Rezoning Transportation Analysis

Petition Number: Insert Zoning Petition #2021-036

General Location Identifier: Tax ID 06306125

Date	Description
04-29-21	First Review (EL)
05-27-21	Second Review (EL)
06-24-21	Third Review (EL)

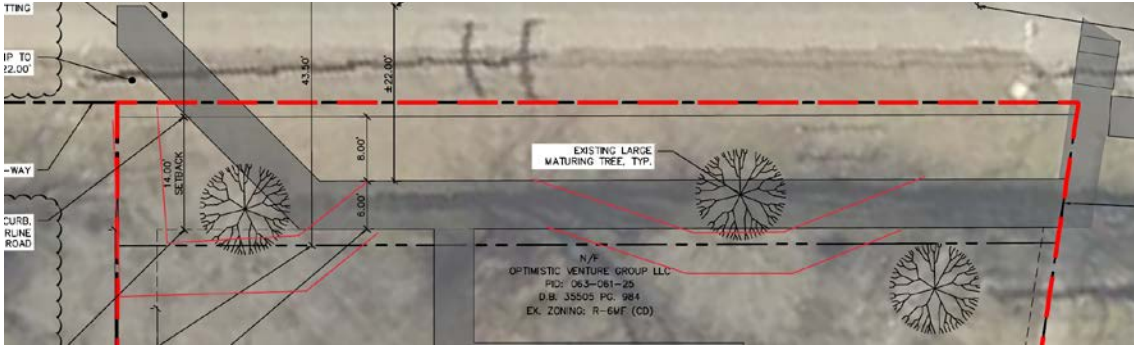
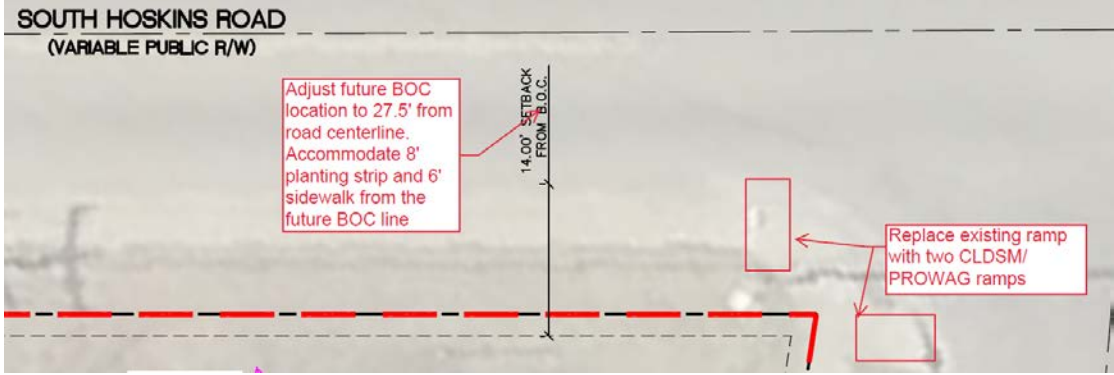
- ~~1. **Curbline:** The proposed zoning district has a setback measured from back of the existing or proposed future curbline.~~
 - ~~a. **South Hoskins Road:** The future location of curb and gutter is 27.5 feet from road centerline. While the existing curb and gutter may remain in place, show the future curbline location for reference.~~

- ~~b. **Gossett Avenue:** The future location of curb and gutter is in its existing location.~~

~~Label and dimension the curb and gutter from the centerline for each road on the site plan.~~

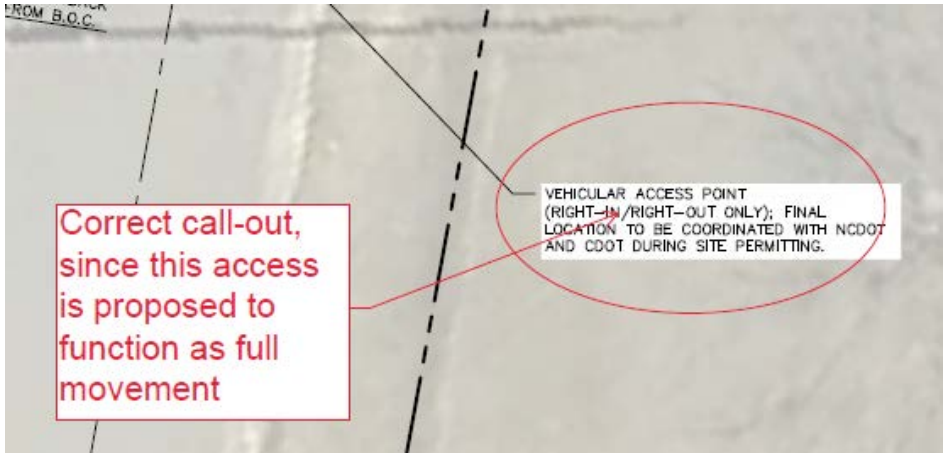
- 4. ~~Site plan and conditional note(s) revisions are needed to dedicate and dimension 43.5 feet of right-of-way from the South Hoskins Road centerline, to accommodate the future cross section that accommodates a buffered bike lane facility per the Charlotte BIKES Council adopted policy.~~
- 5. ~~Site plan and conditional note(s) revisions are needed to correct the driveway call-out below.~~
